Errata

Title & Document Type: 8614A Signal Generator Operating and Service Manual

Manual Part Number: 08614-90001

Revision Date: March 1979

P/O Figure 5-14. Repeller Mode Adjust Setup

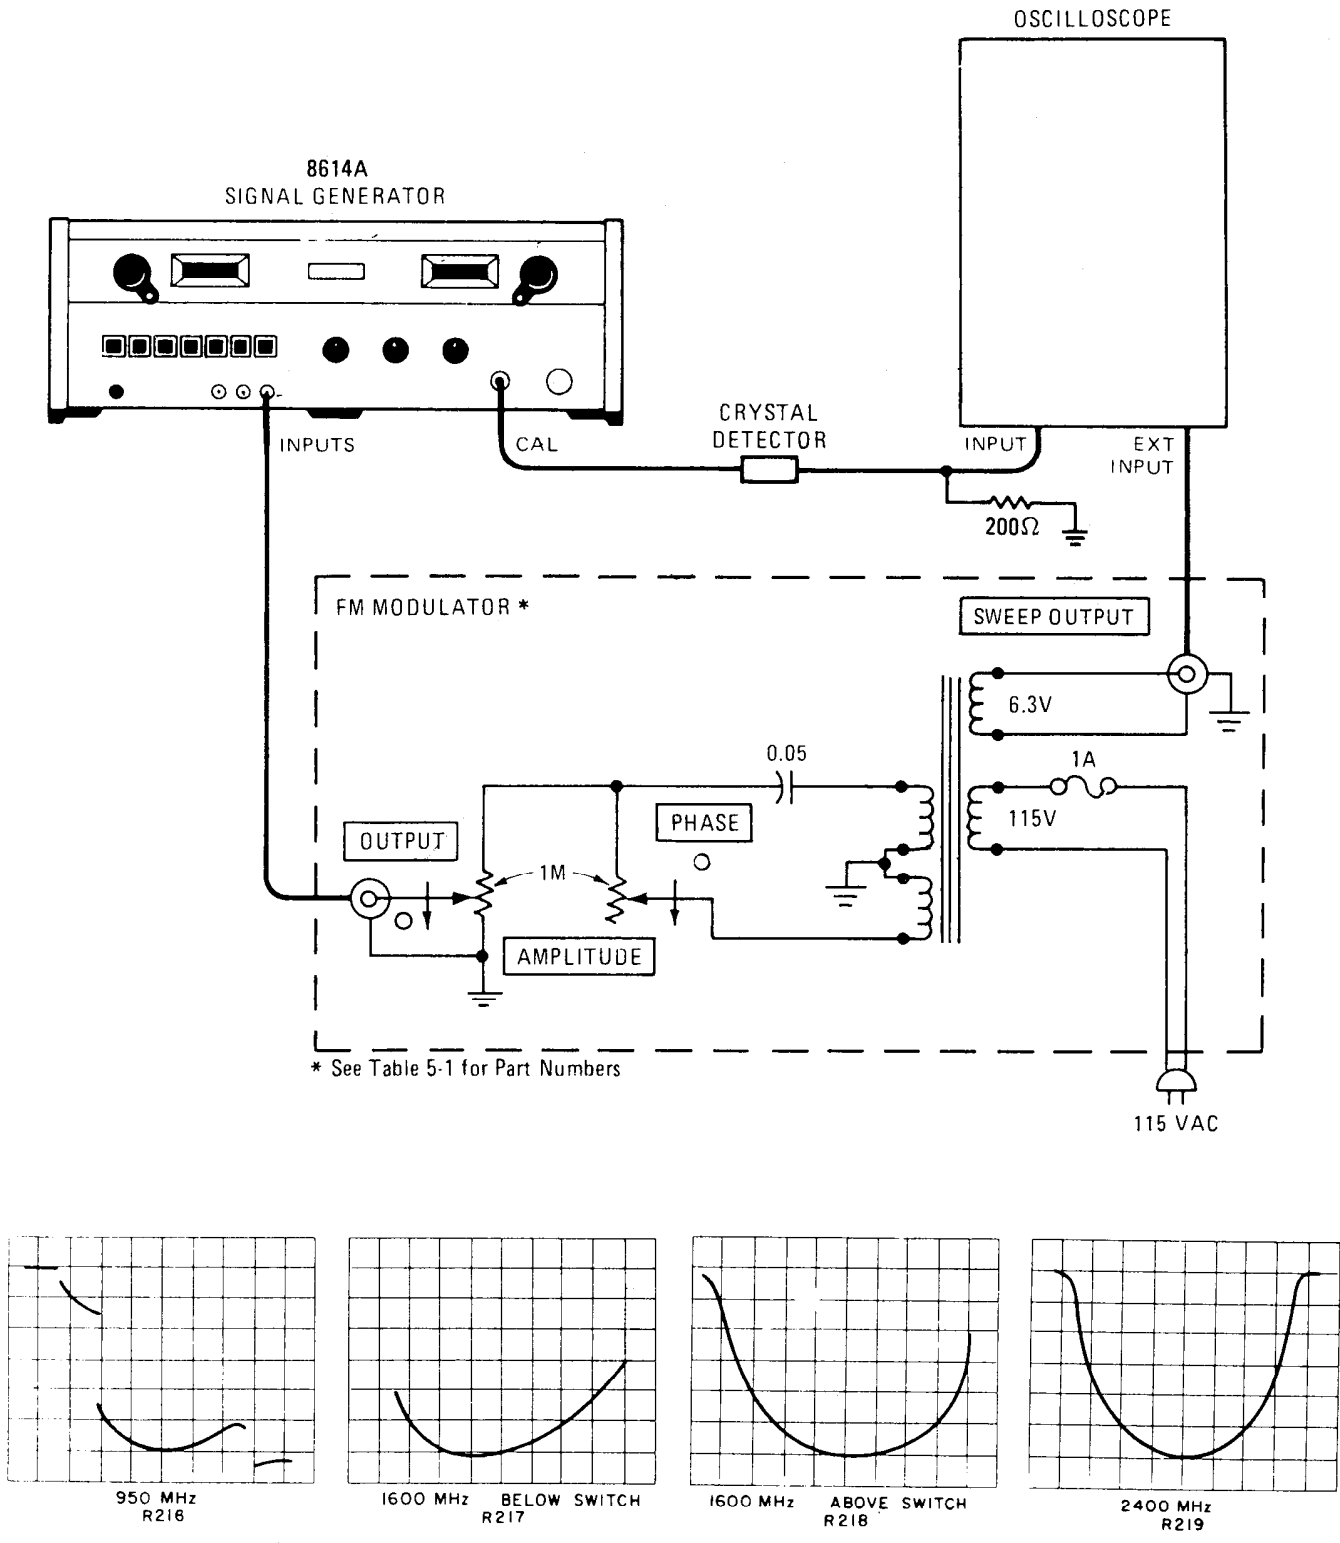
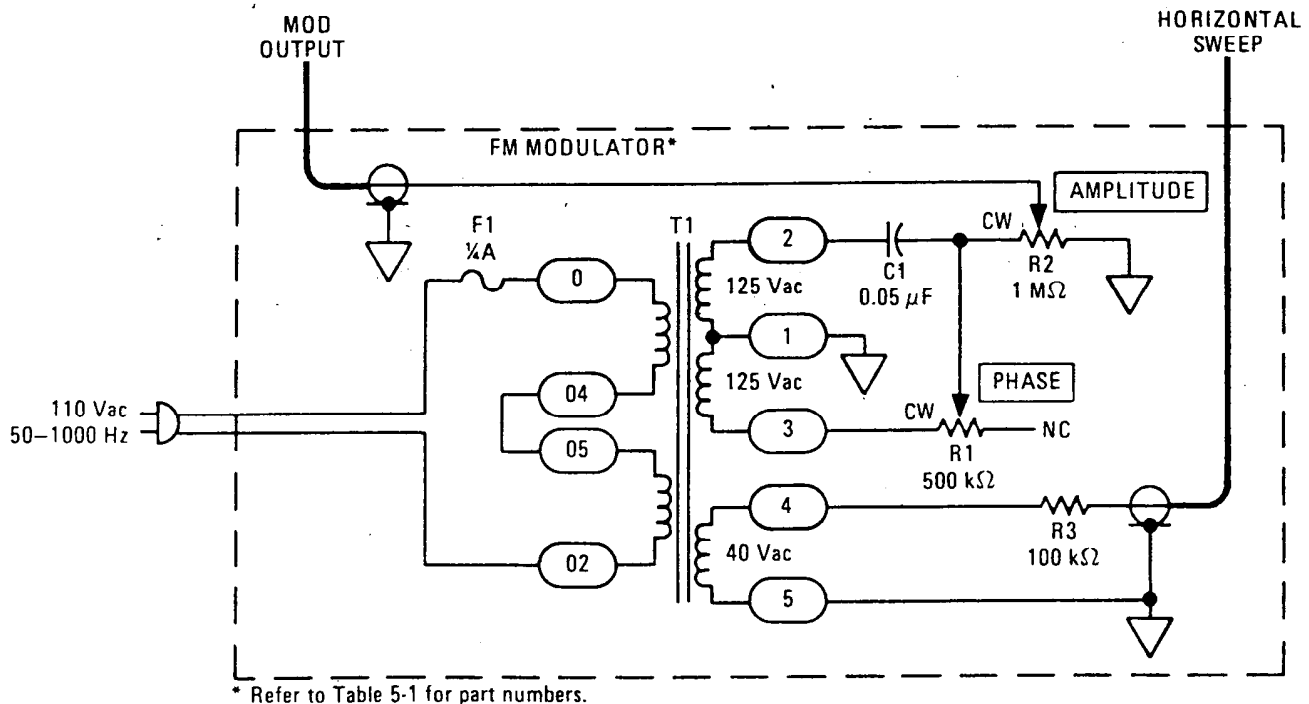
Page 5-20, Figure 5-14:

Replace the FM MODULATOR portion with the one shown below.

Figure 1. High Voltage Board (A100)

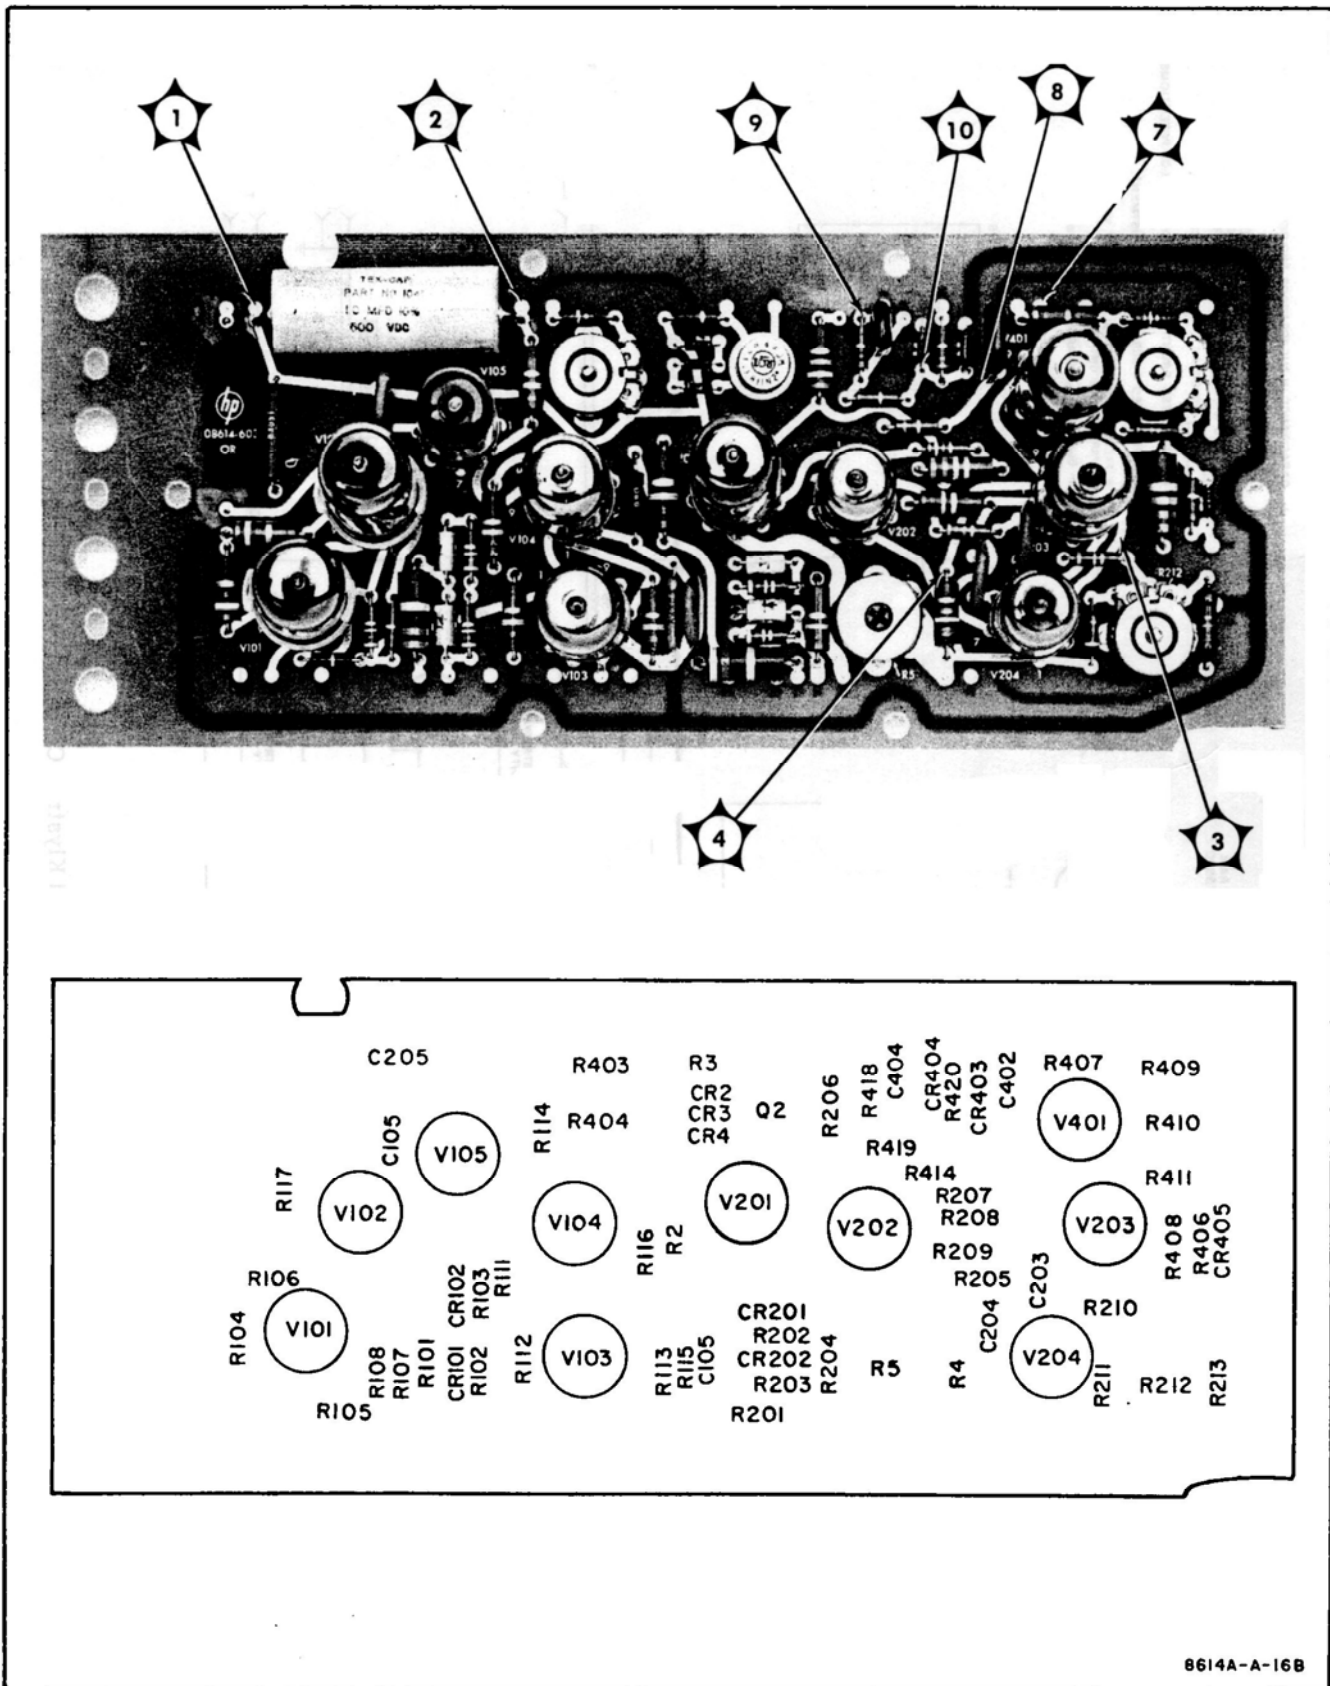
Figure 5-21 and Figure 5-24, High-Voltage Board (A100),
 Replace with component location and test point picture, Figure 1 (shown in this Appendix)

Figure 3. Partial Schematic

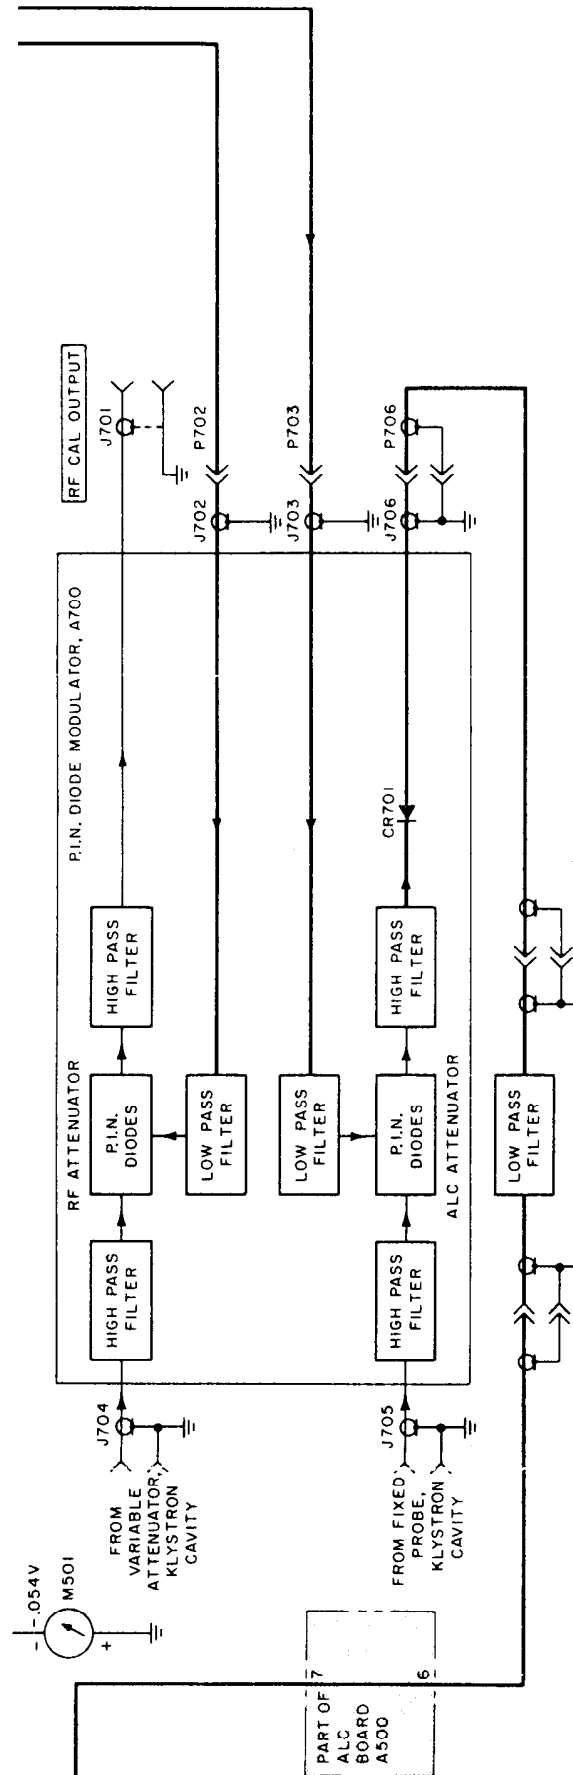
Page 5-33/5-34, Figure 5-27,
Change as shown in partial schematic (Figure 3 Partial) shown at end of this appendix.

P/O Figure 5-26. Modulation and Klystron Circuits (P/O Change 3)

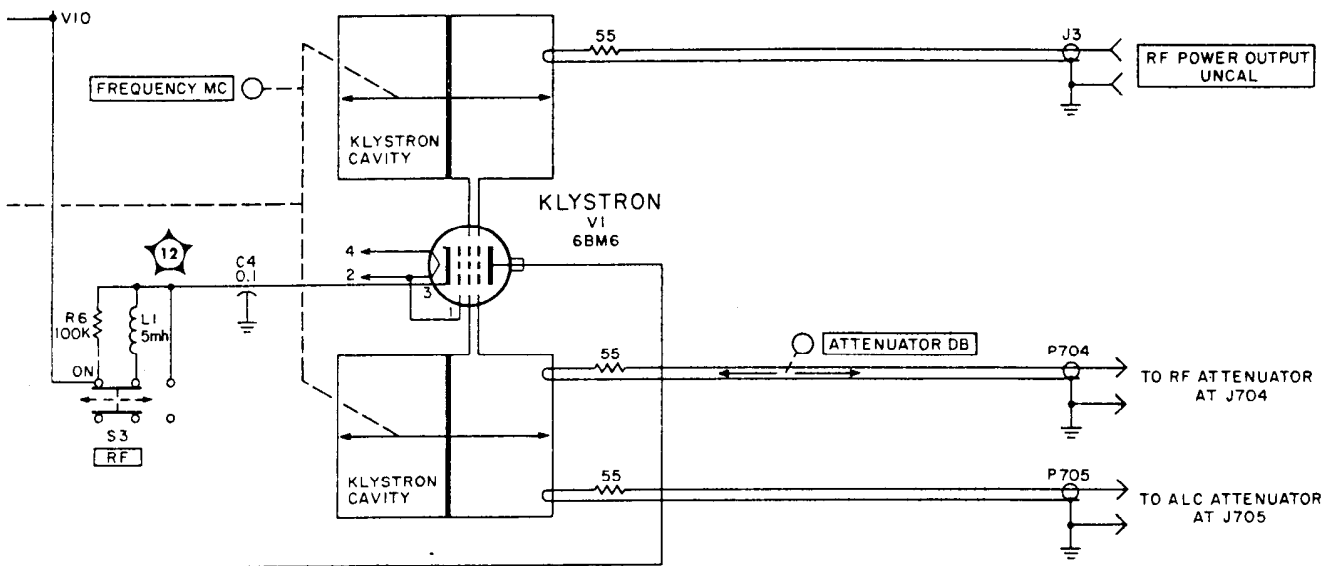
Page 5-31/5-32, Figure 5-26:

Replace appropriate portions of figure with the attached partial schematic.

P/O Figure 5-26. Modulation and Klystron Circuits (P/O Change 3)

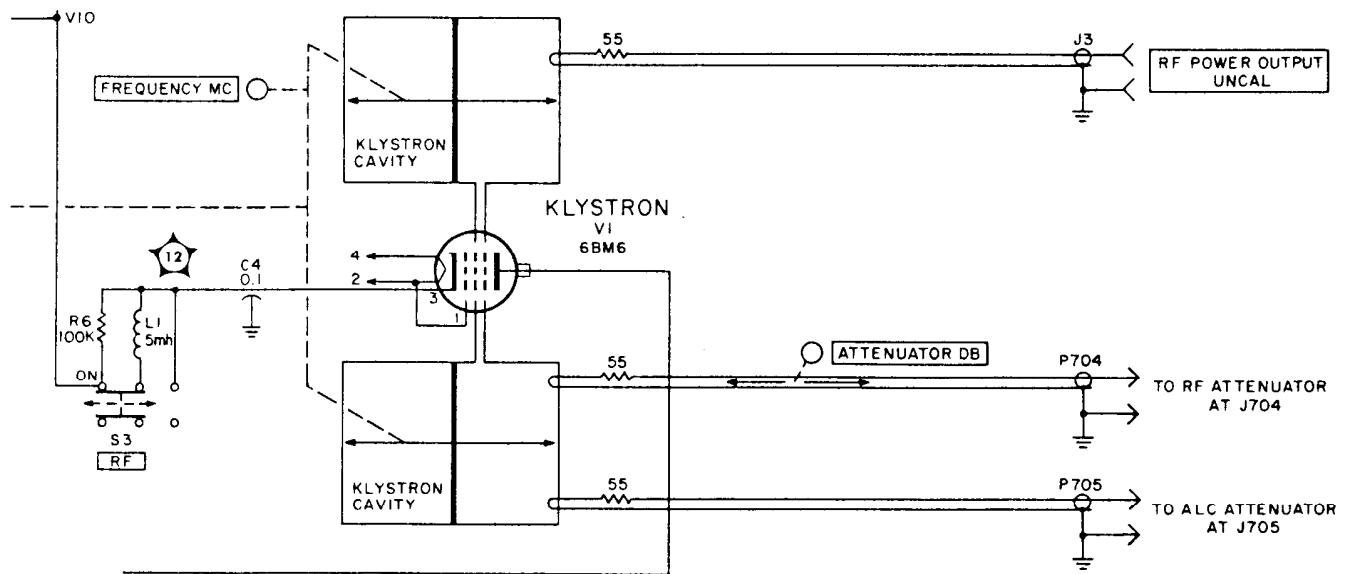
Page 5-35, Figure 5-26:

Replace appropriate portions of figure with the attached partial schematic.
